# PlanGrid Task Report - Aug 8, 2024

10 tasks in this report.

**L04954\_Chapel Hill University Place FSU (NC)**

IMG\_5087

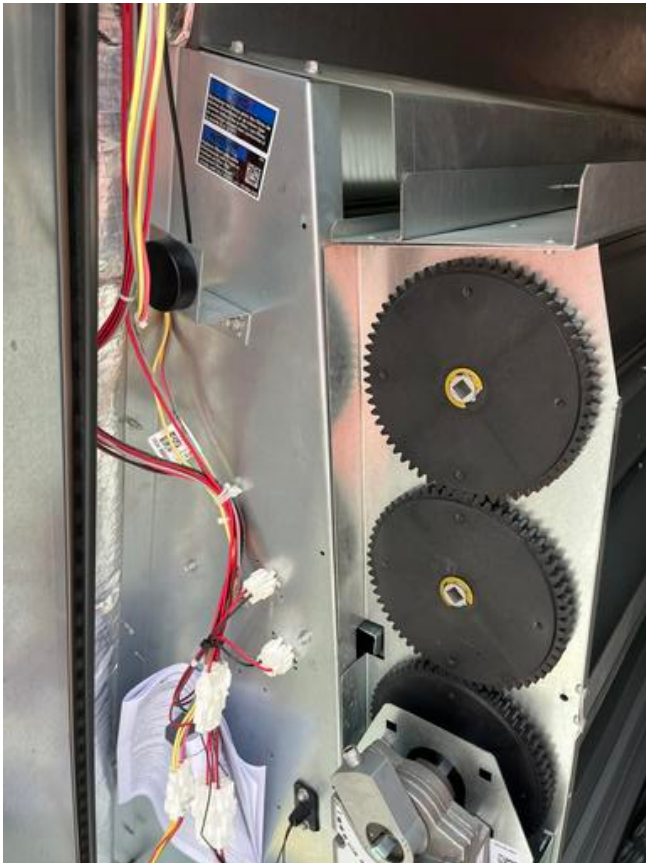
AC1 econ is missing a factory installed block off plate to seal outside air canopy.
